DRAINAGE PLAN
STA. 145+00 TO 150+00

FARRINGTON HIGHWAY INTERSECTION IMPROVEMENTS
AT NANAKULI AVENUE AND HALEAKALA AVENUE
Federal-Aid Project No. STP-093-1(22)

CONTRACT CHANGE ORDER NO. 27
Attachment 1

DRAINAGE PROFILES - 3

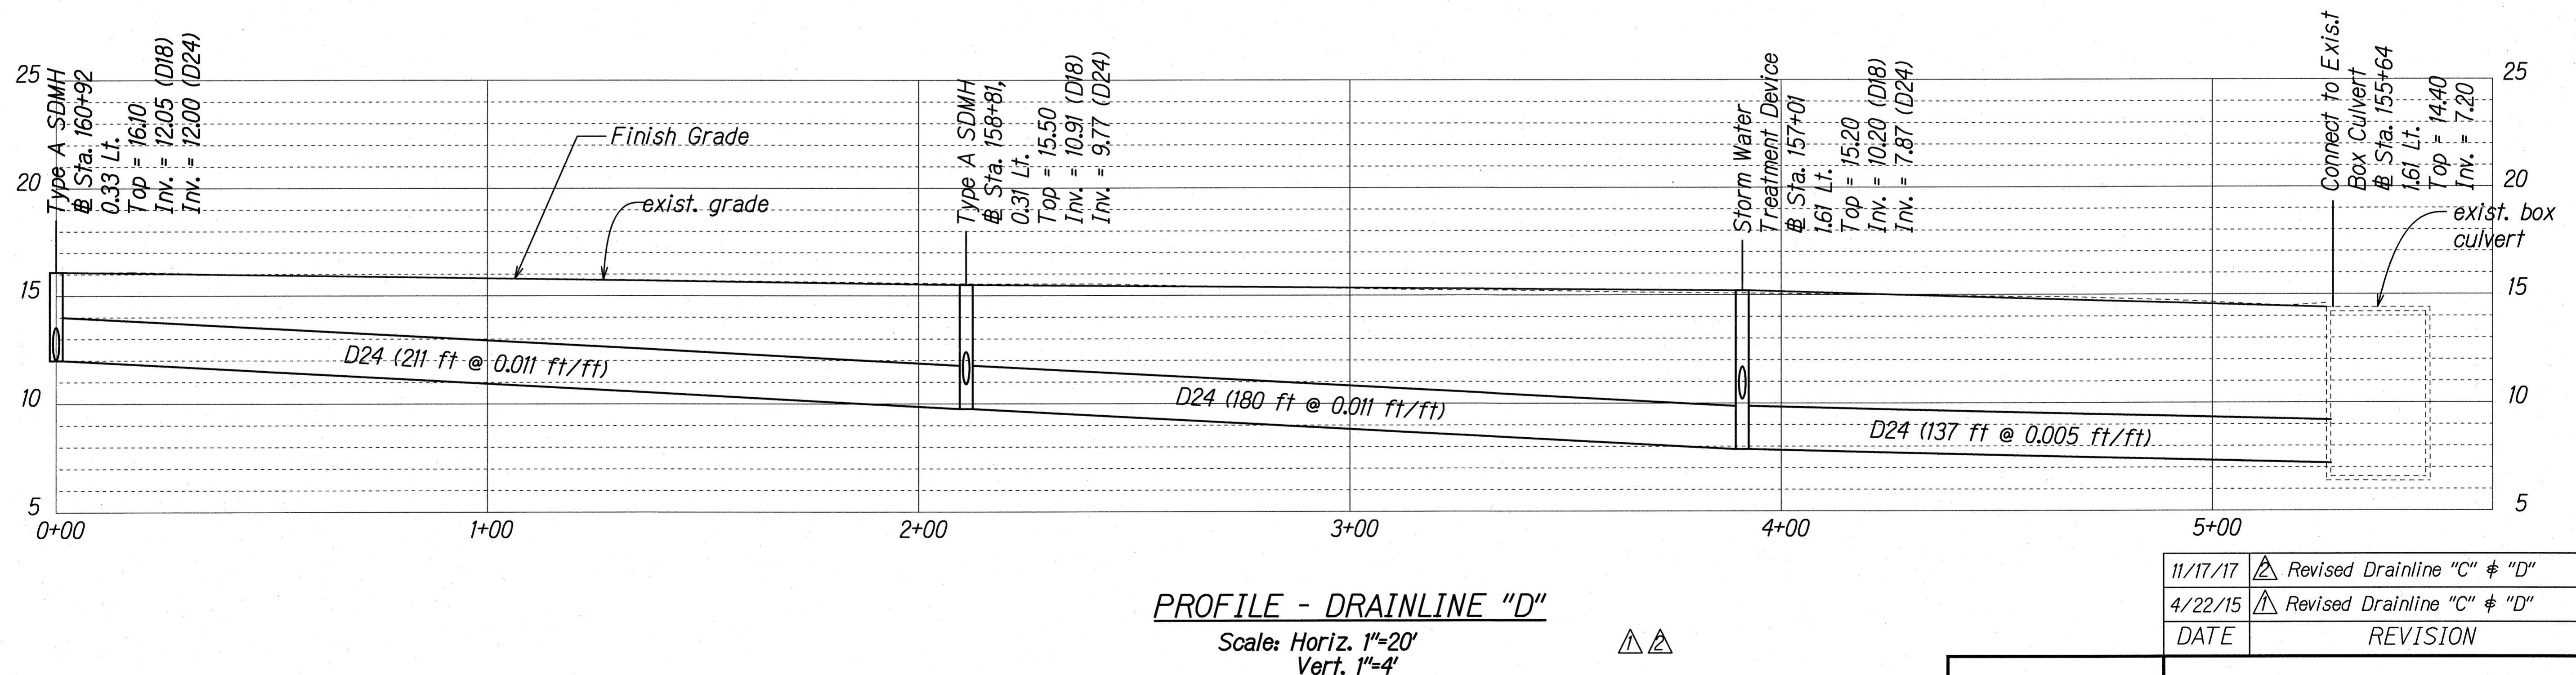
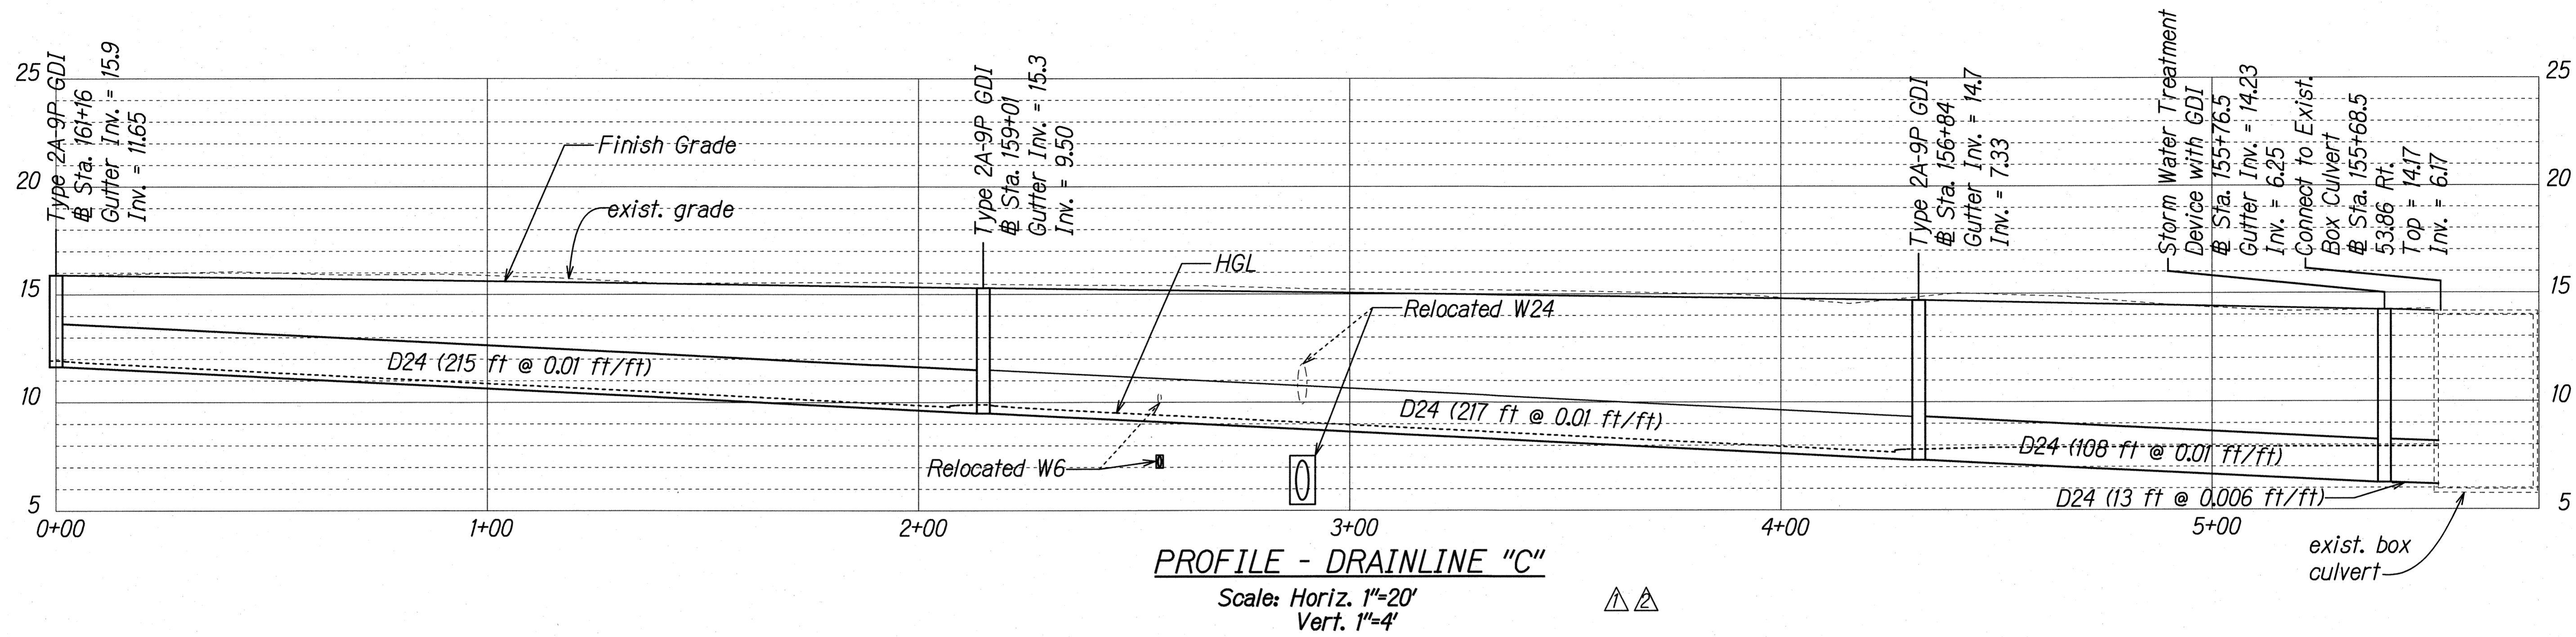
11/17/17	Revised Drainline "C" & "D"
4/22/15	Revised Drainline "C" & "D"
DATE	REVISION

DRAINAGE PROFILES - 4

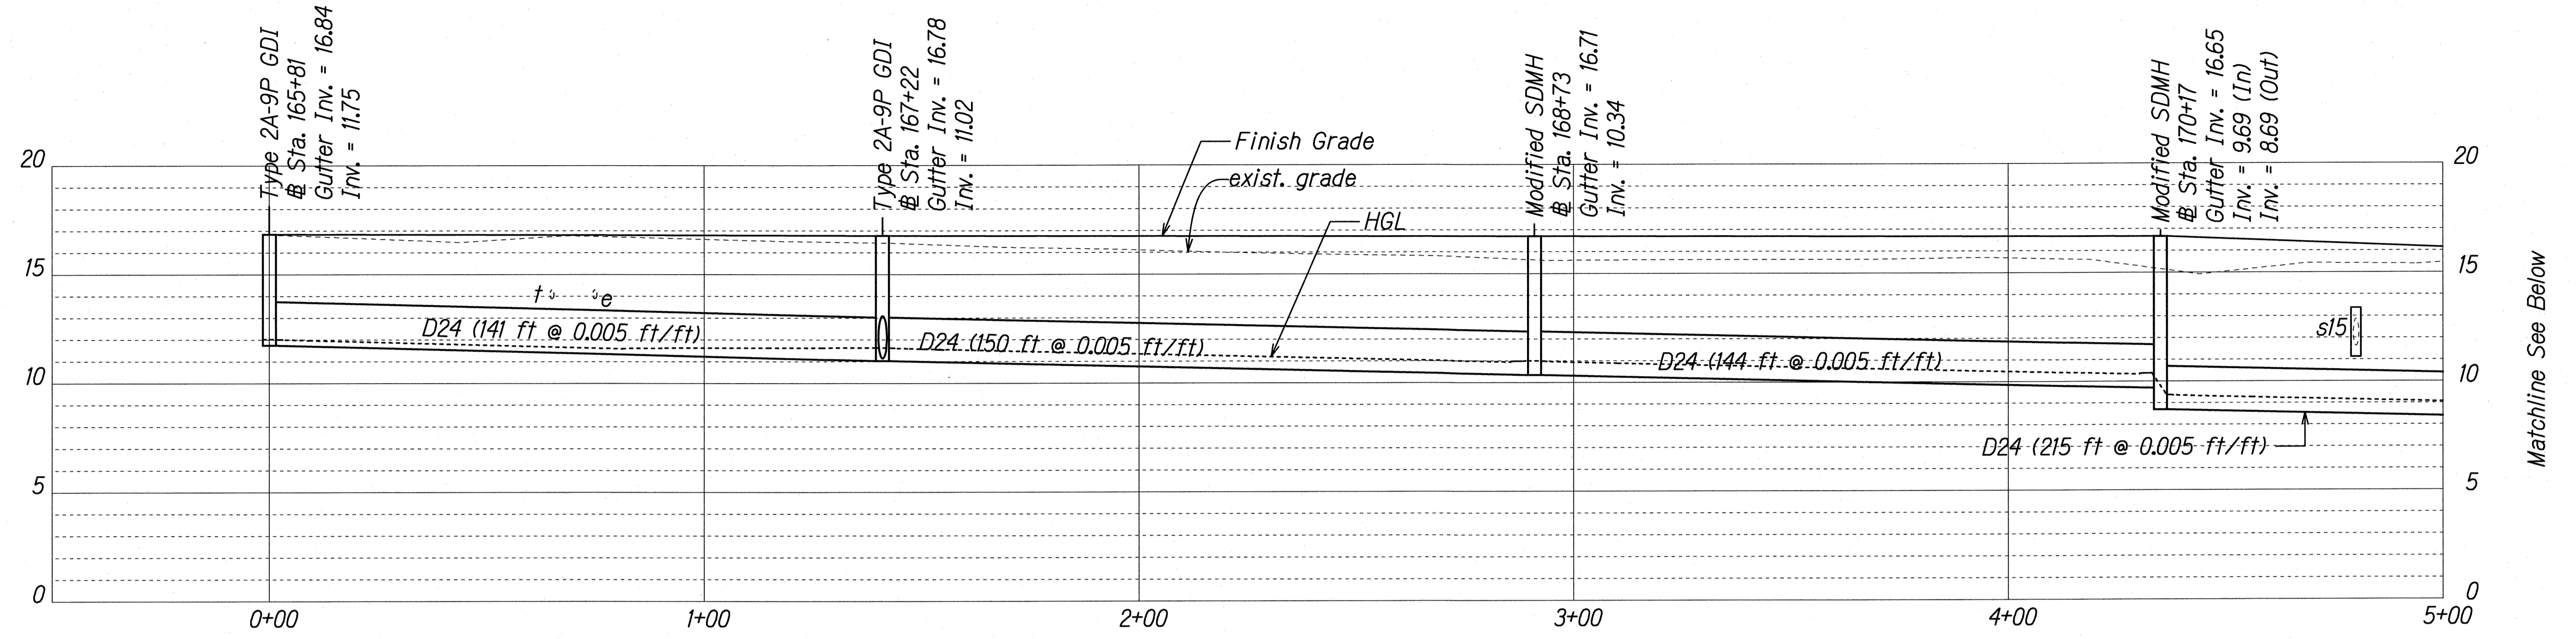
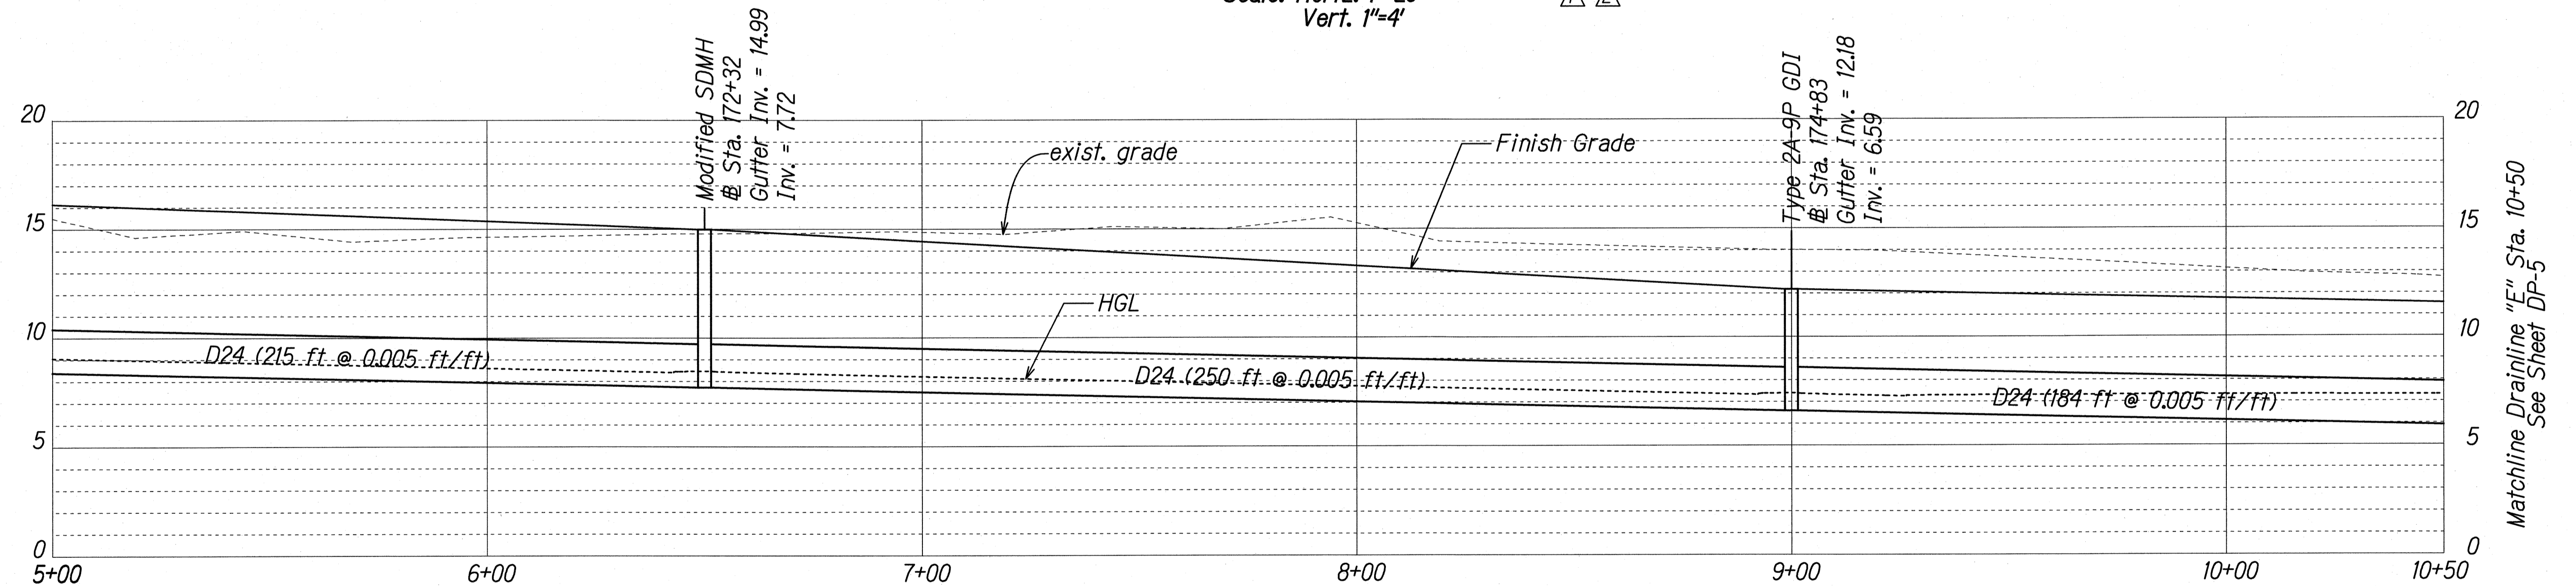
11/17/17	Revised Drainline "E"
4/3/15	Revised Drainline "E"
DATE	REVISION
